# Environmental Impact Statement

Request for Project Change 4

April 2019

**Queensland**  
Government

Figure 3.5: Evaluated Exhibition Station Site Plan

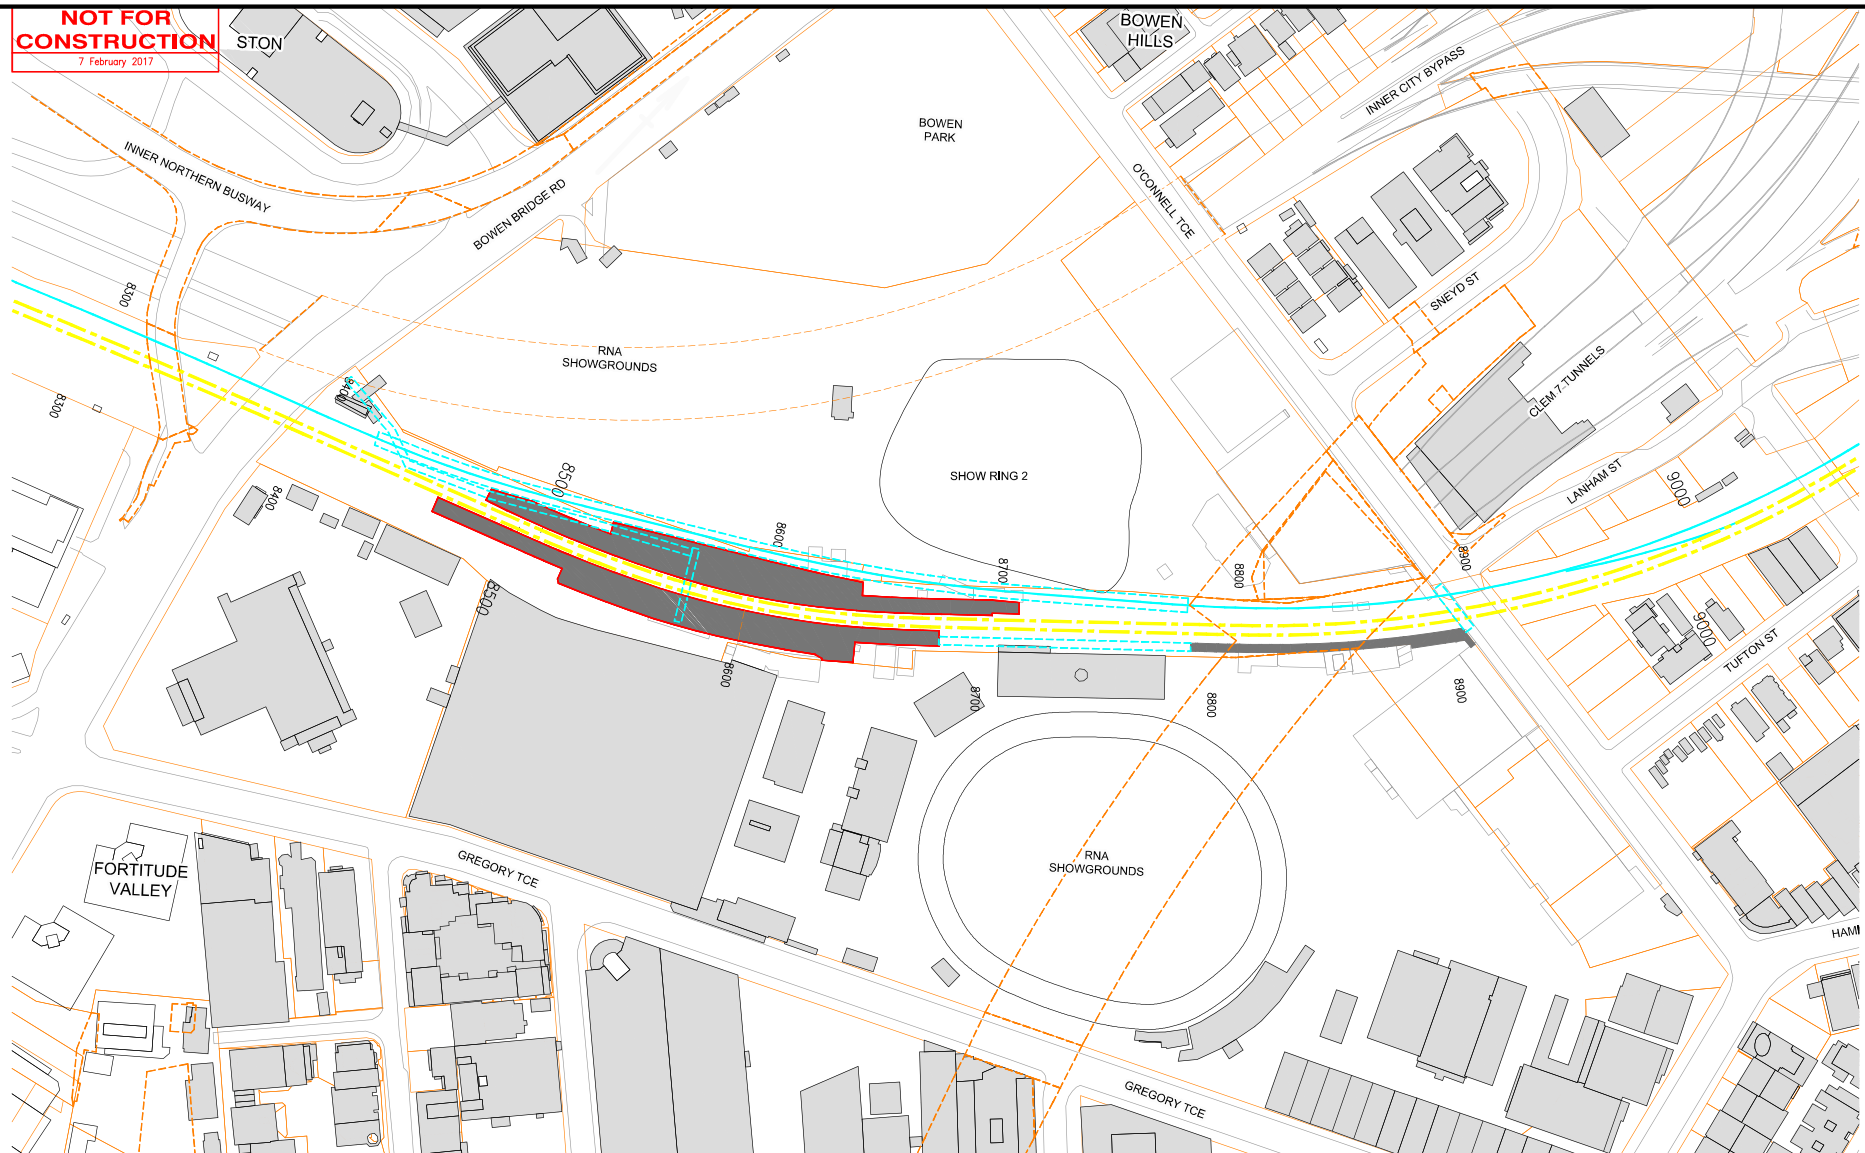
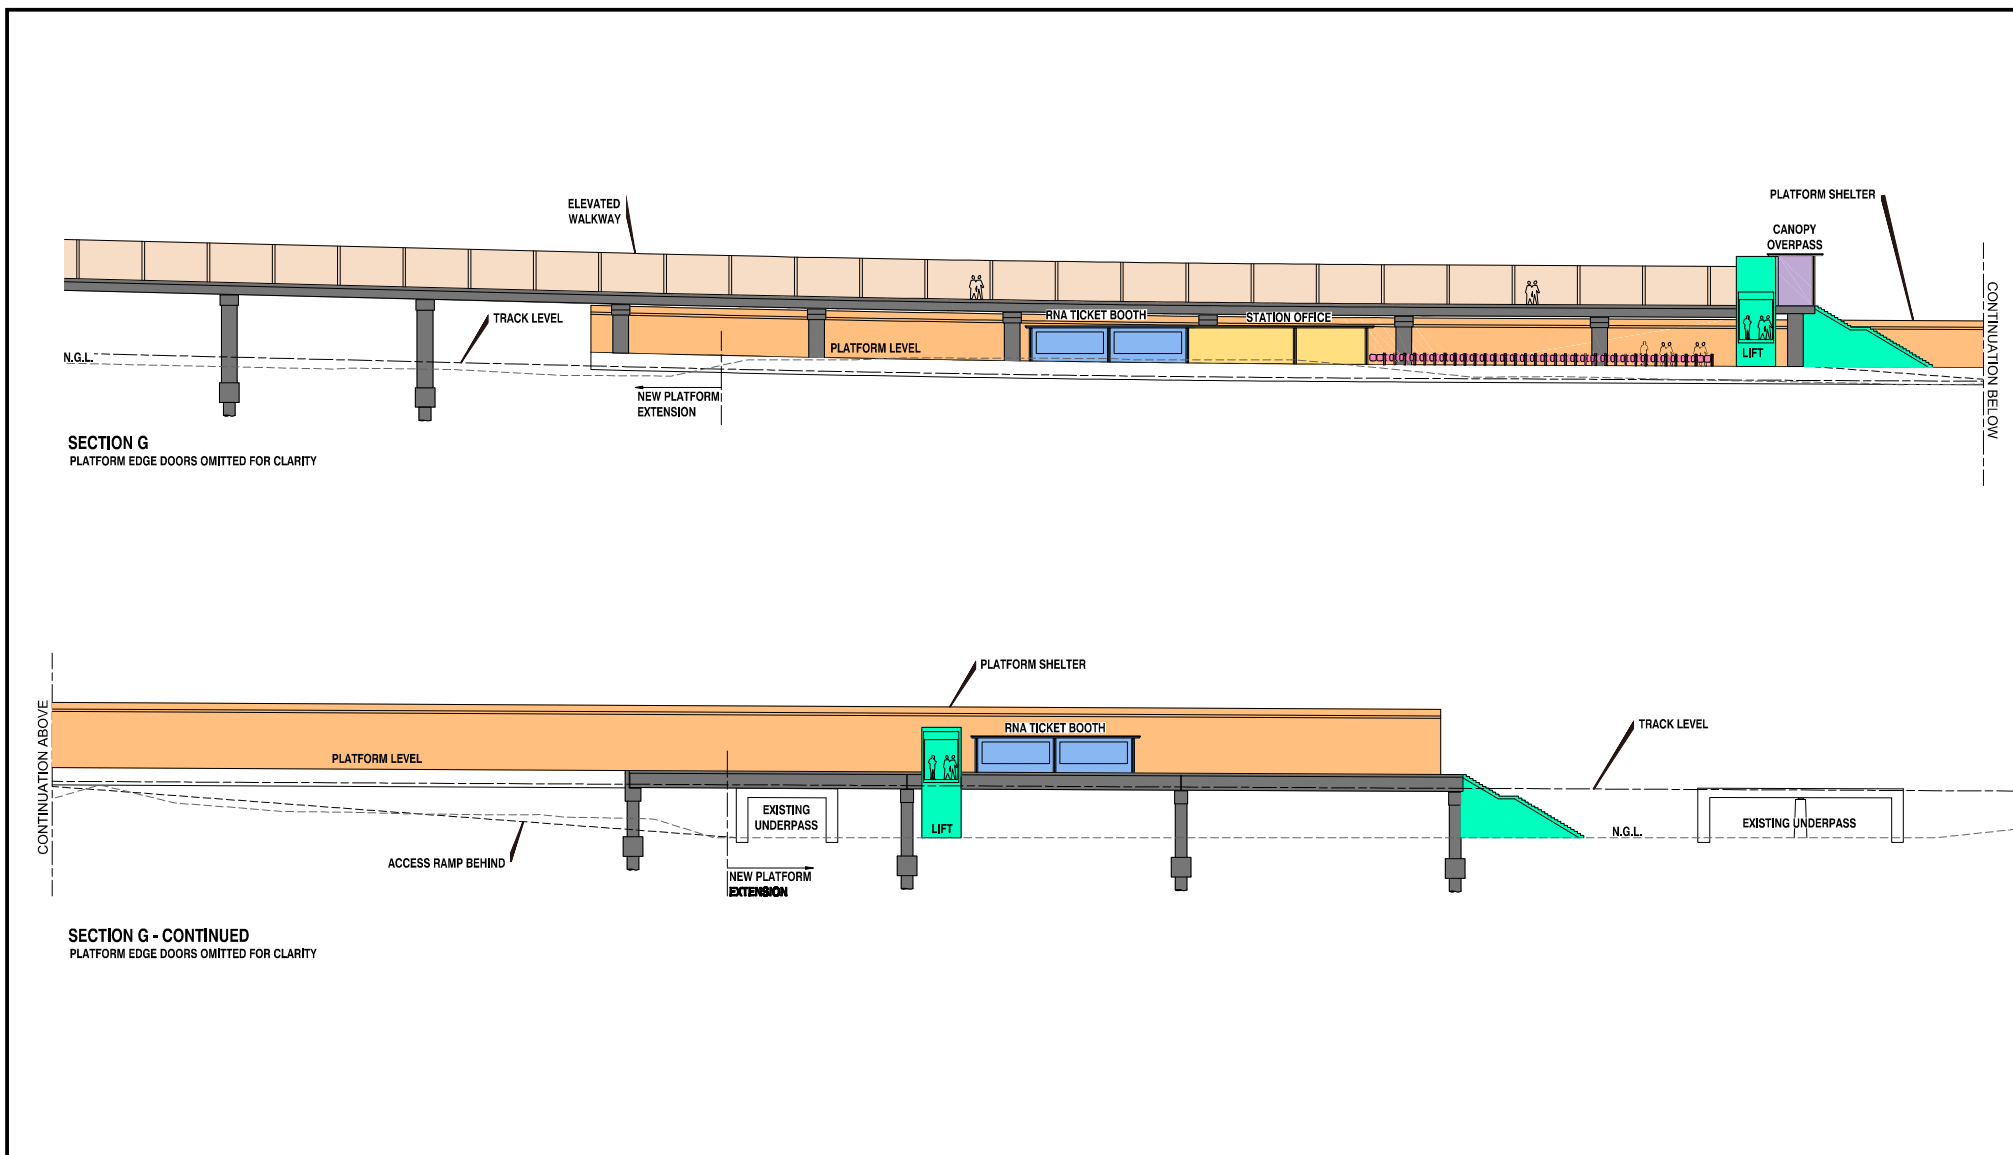
The Proposed Changes to the Exhibition Station site plan are provided in Figure 3.7.

Figure 3.9: Change to Roma Street Station Location

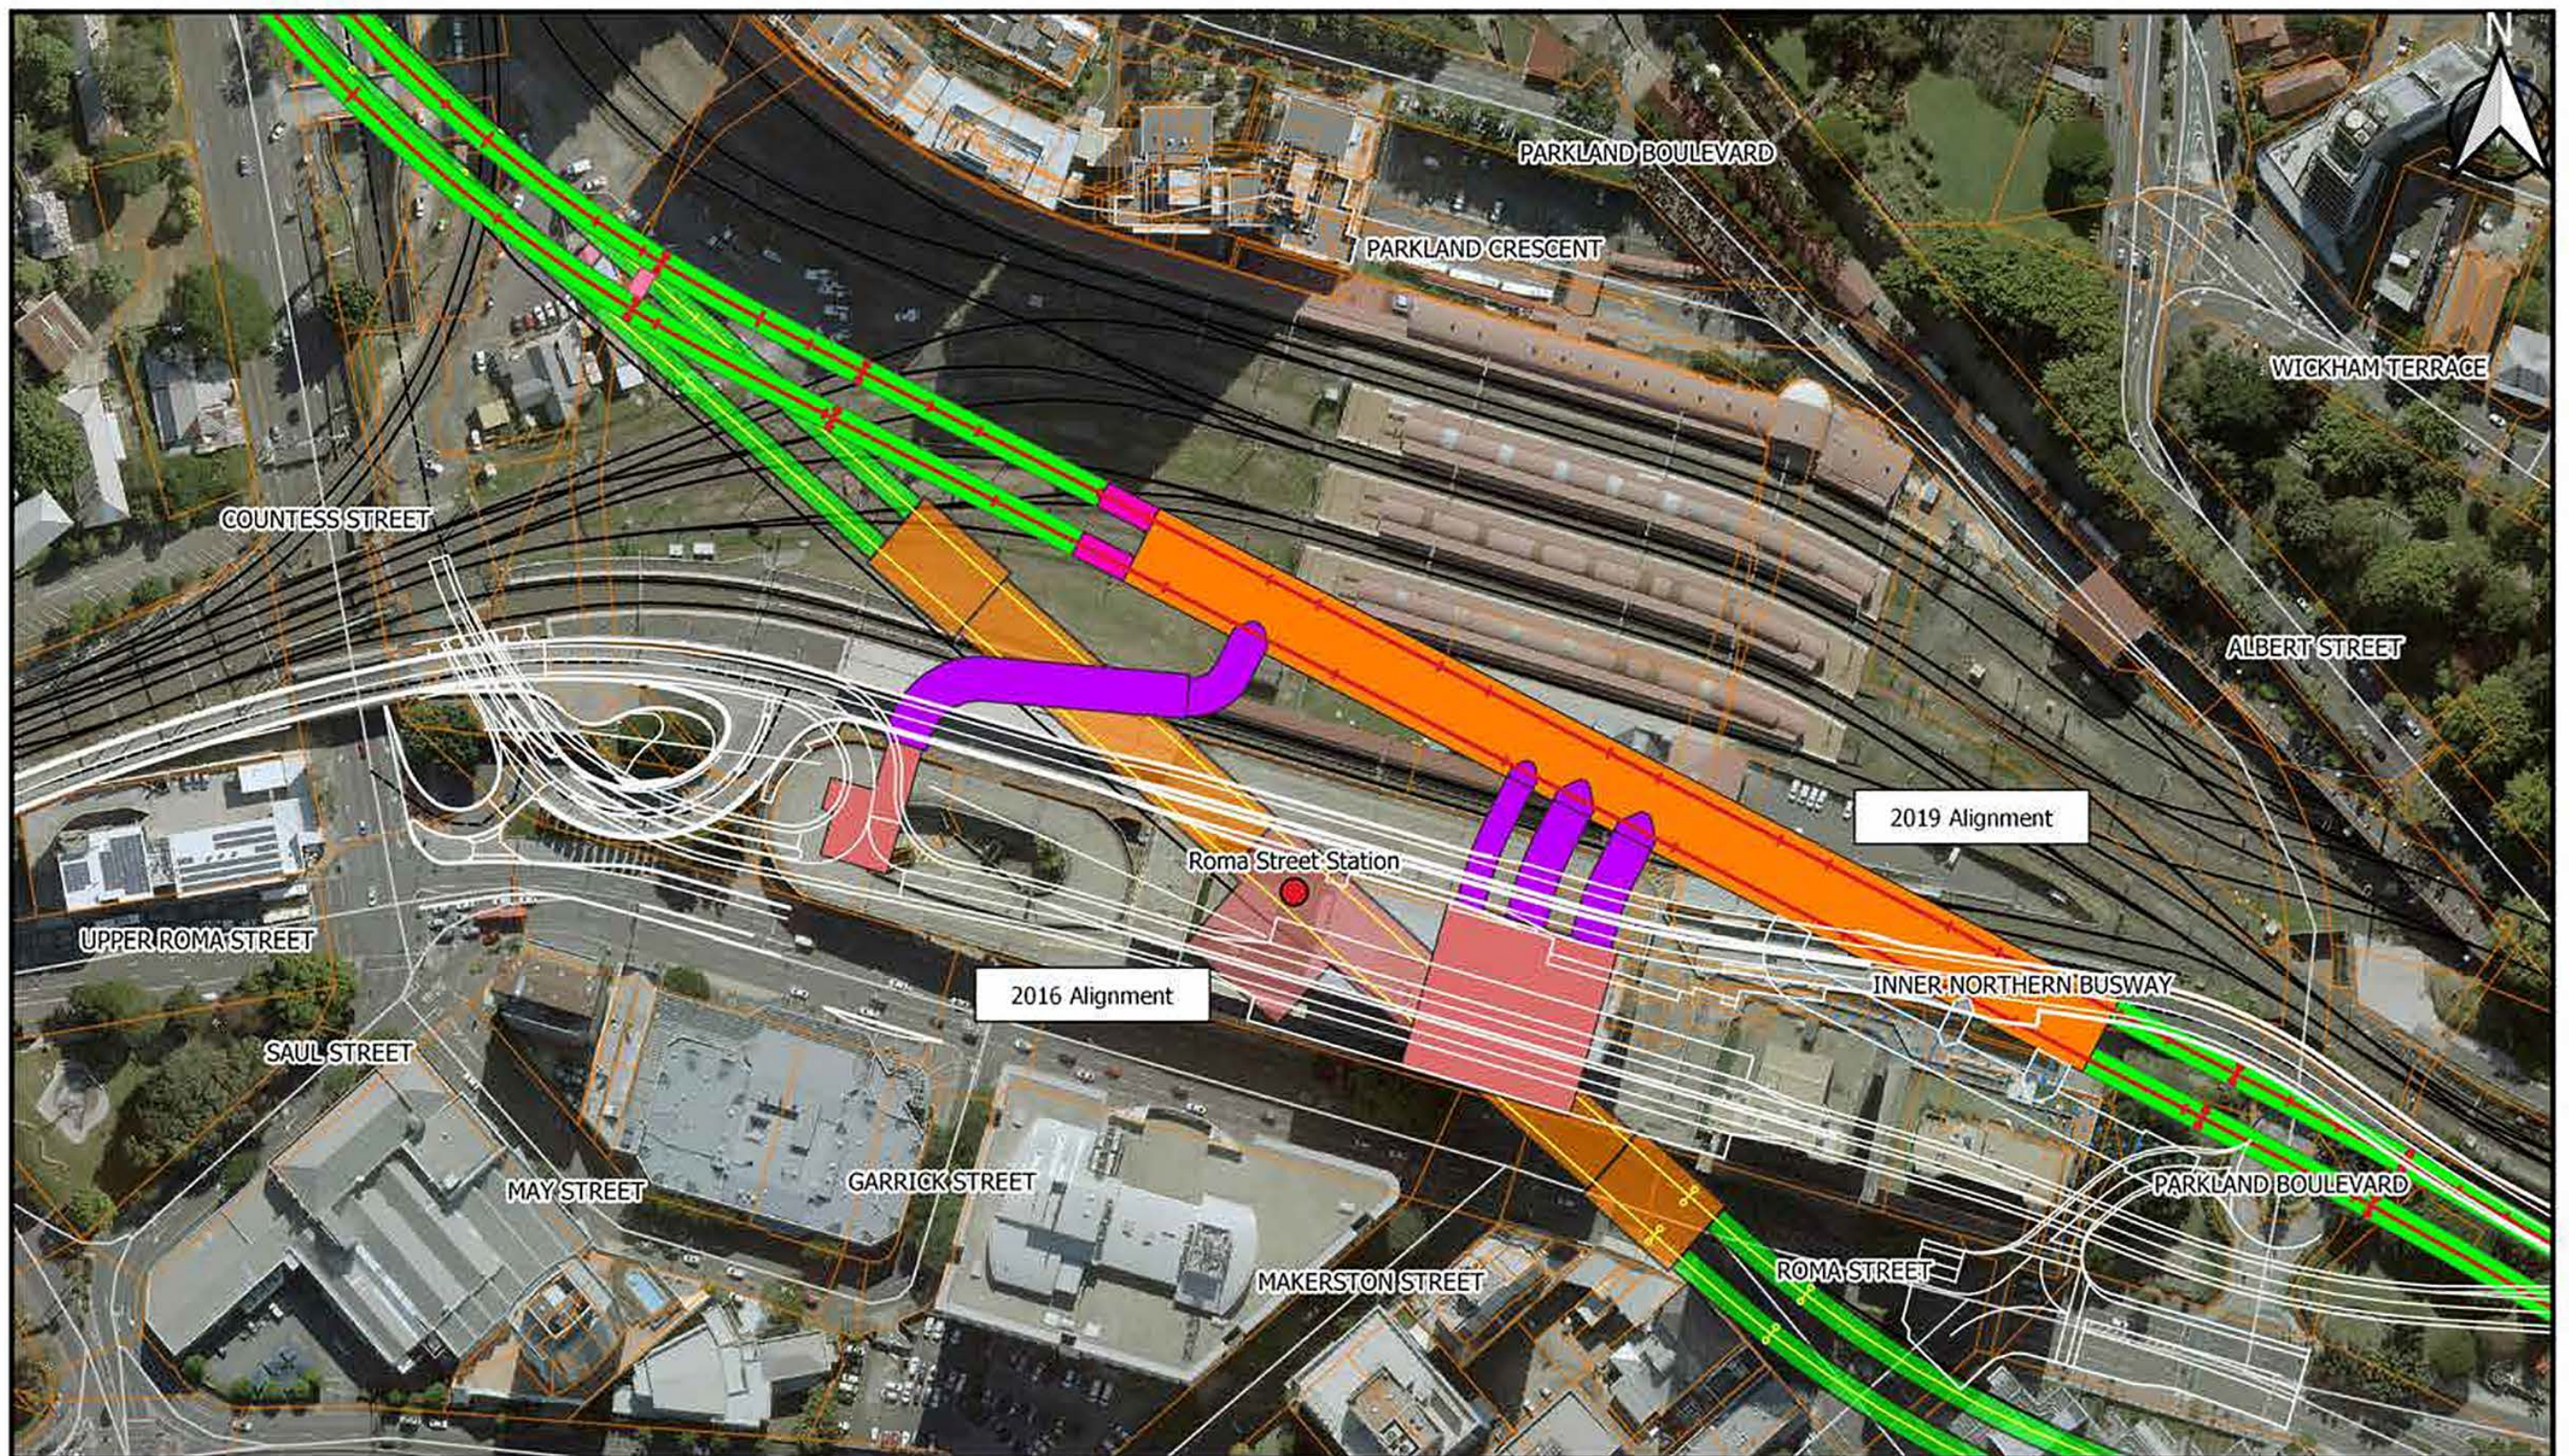
Due to the changed tunnel alignment, the location of the proposed underground CRR Roma Street Station has been relocated to the east under the rail yards, as shown in Figure 3.9. The station design includes a service building at the western end, emergency egress shaft at the eastern end and a single plaza entry at the centre of the station. The Proposed Change improves future flexibility of land use for the properties along the Roma Street frontage and increases the availability of the area for future precinct developments, such as Brisbane Live. The changed general perspective is shown in Figure 3.10 and two station cross sections in Figure 3.11 and Figure 3.12.

Figure 3.16 Proposed Albert Street Station general perspective

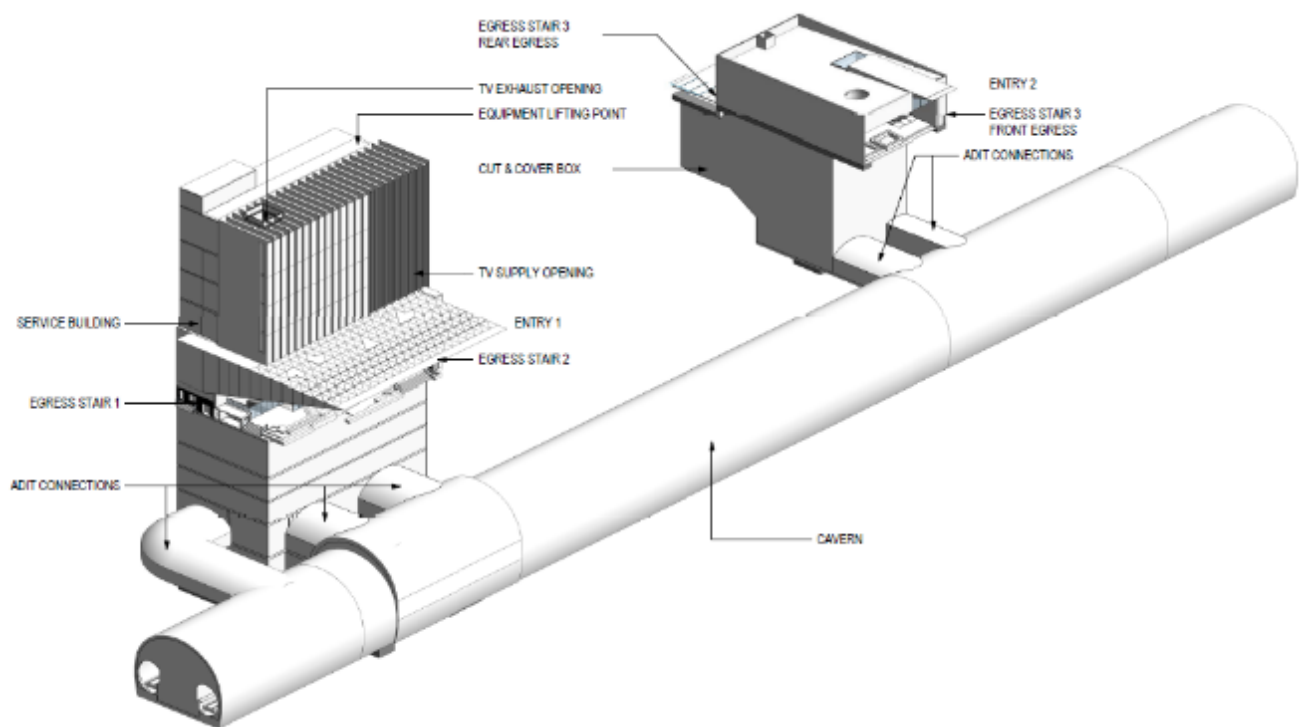
The Evaluated Project's CRR Albert Street Station cavern was to be beneath Albert Street between Margaret Street and Elizabeth Street. The station cavern is now proposed to be shifted approximately 80m north-west along the alignment towards Roma Street to optimize the station catchment, as shown in Figure 3.14.

The cavern profile has also been increased in size to provide a mezzanine level and the multiple street entrances consolidated into two plaza entrances. The southern entrance is at the junction of Albert Street and Mary Street and the northern entrance at 142 Albert Street. Removal of street entrances along Albert Street. By removing street structures from the roadway and adjacent footpaths, the Project complements BCC's Albert Street Vision, with the plaza entrances providing a public space to

A general perspective of the station is shown in Figure 3.16 and a cross section in Figure 3.17.
